Date: AUG 18 2016
Symbol: EPC-DO-16-198
LA-UR: 16-24661
Locates Action No.: N/A

Subject: Transmittal of Class 1 Permit Modification Request to Remove Structures from the Los Alamos National Laboratory (LANL) Hazardous Waste Facility Permit, EPA ID No. NM0890010515

**Class 1 Permit Modification Request for Removal of Three
Structures (RTR1, RTR2, and MCS HENC) from Technical
Area 54**

Figure G.11-1: Technical Area 54, Area G, Pad 10 Outdoor Container Storage Unit Grid Sampling and Additional Sampling Locations

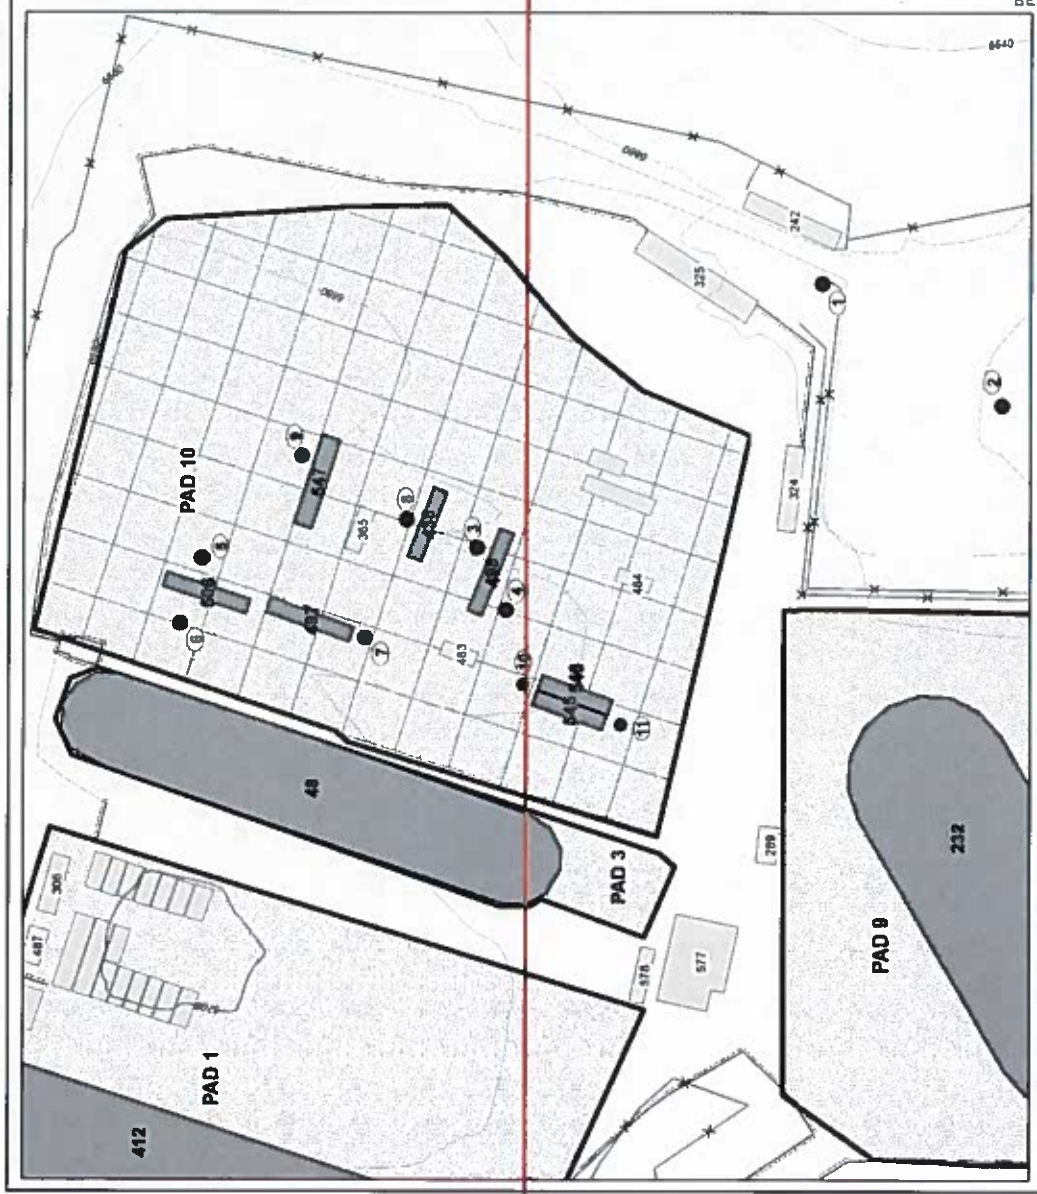
Attachment G.11, *Technical Area 54, Area G, Pad 10 Outdoor Container Storage Unit Closure Plan*, proposed revision reflects removal of the RTR2 (TA-54-0497) and MCS HENC (TA-54-0506) structures from the description of unit to be closed. A statement has been added to Section 2.0 noting the removal of the RTR2 and MCS HENC non-intrusive waste characterization structures in 2016. Figure G.11-1 *Technical Area 54, Area G, Pad 10 Outdoor Container Storage Unit Sampling Grid and Additional Sampling Locations* proposed revision reflects removal of the RTR2 and MCS HENC structures, however, the unloading area sample locations remain as required sample locations for execution of the G.11 closure plan.

Figure G.12-1: Technical Area 54, Area G, Pad 11 Outdoor Container Storage Unit Grid Sampling and Additional Sampling Locations

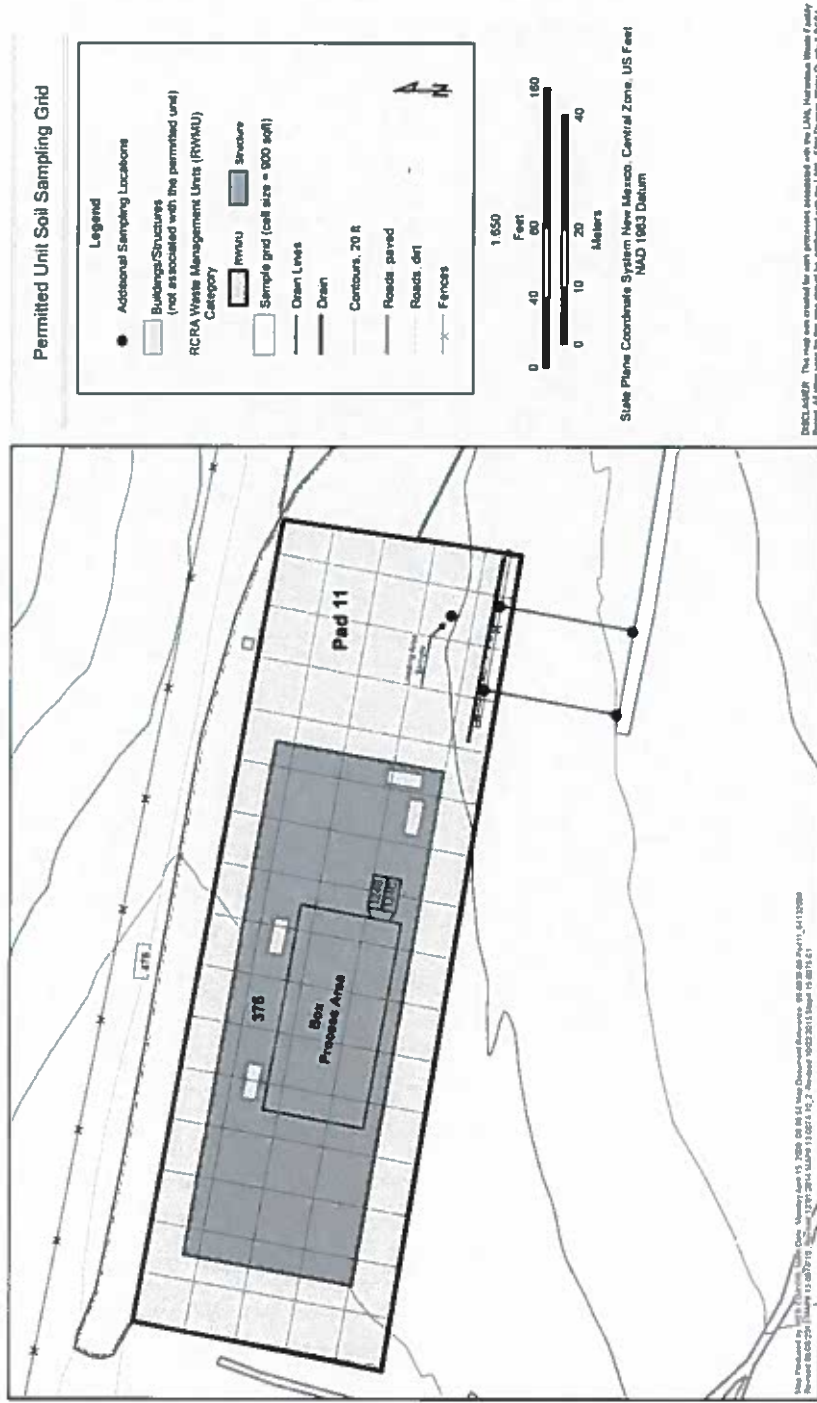
Attachment G.12, *Technical Area 54, Area G, Pad 11 Outdoor Container Storage Unit Closure Plan*, proposed revision reflects removal of the RTR1 (TA-54-0362) modular characterization equipment trailer (e.g., structure) from the description of unit to be closed. A statement has been added to Section 2.0 noting the removal of the RTR2 and MCS HENC non-intrusive waste characterization structures in 2016. Figure G.12-1 *Technical Area 54, Area G, Pad 11 Outdoor Container Storage Unit Sampling Grid and Additional Sampling Locations* proposed revision reflects removal of the RTR1 structure, however, the existing unloading area sample locations remain, as required, as sample locations for execution of the G.12 closure plan. In addition, table call outs in Attachment G.12, Sections 5.3.2 and 6.4.2.1 were incorrectly labeled as Tables G.12-8 and G.12-7 and have been corrected to Tables G.12-6 and G.12-5, respectively. Track change format copies of both revised pages are provided.

Figure 27: Technical Area 54, Area G, Container Storage Units

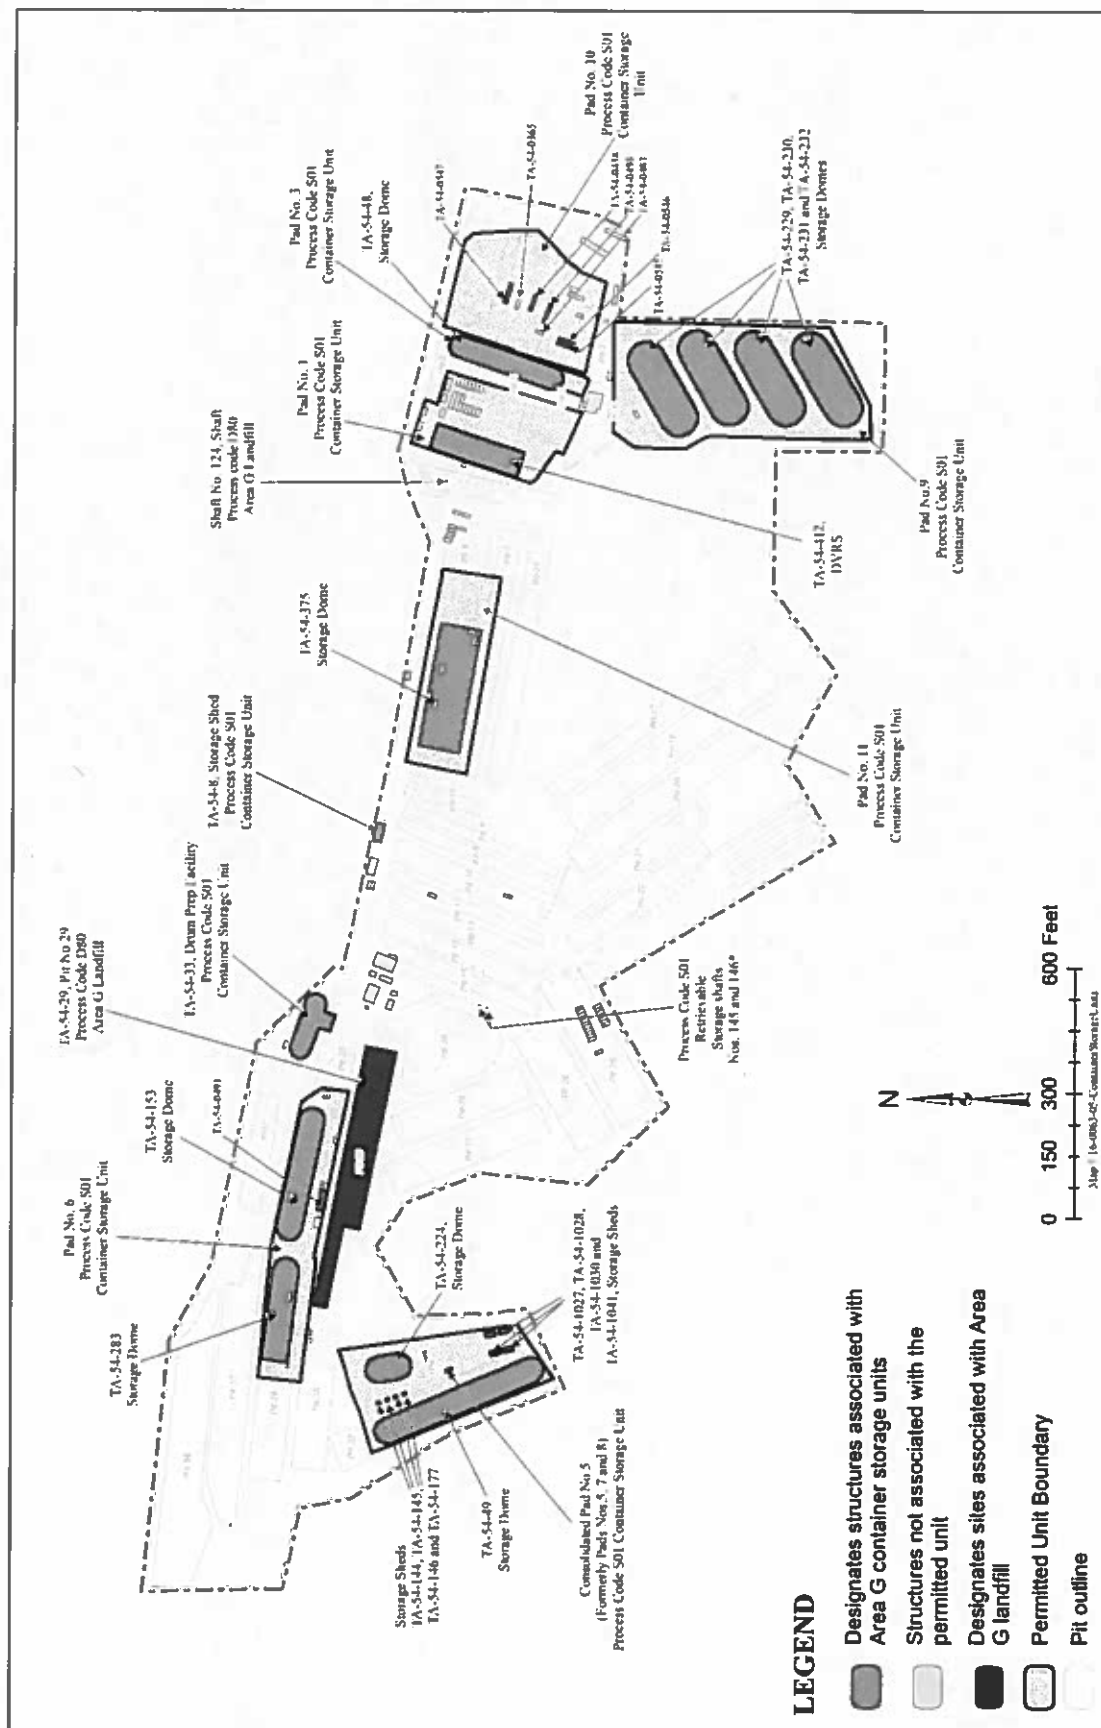
Attachment N, *Figures*, reflects the proposed removal of the three structures from Figures 27, 31 and 36. Figure 27, *Technical Area 54, Area G, Container Storage Units*, revision reflects the proposed removal of two structures (TA-54-0497 and TA-54-0506) from Pad 10, and the proposed removal of a single structure from Pad 11 (TA-54-0360). Figure 27 revisions also reflect the removal of structure TA-54-1059. The removal of TA-54-1059 was approved by NMED for re-location from TA-54 Pad 10 to TA-54 Pad 1 on May 18, 2016 in acceptance of Permit Modification Notification EPC-DO-16-056/LA-UR-16-21078.
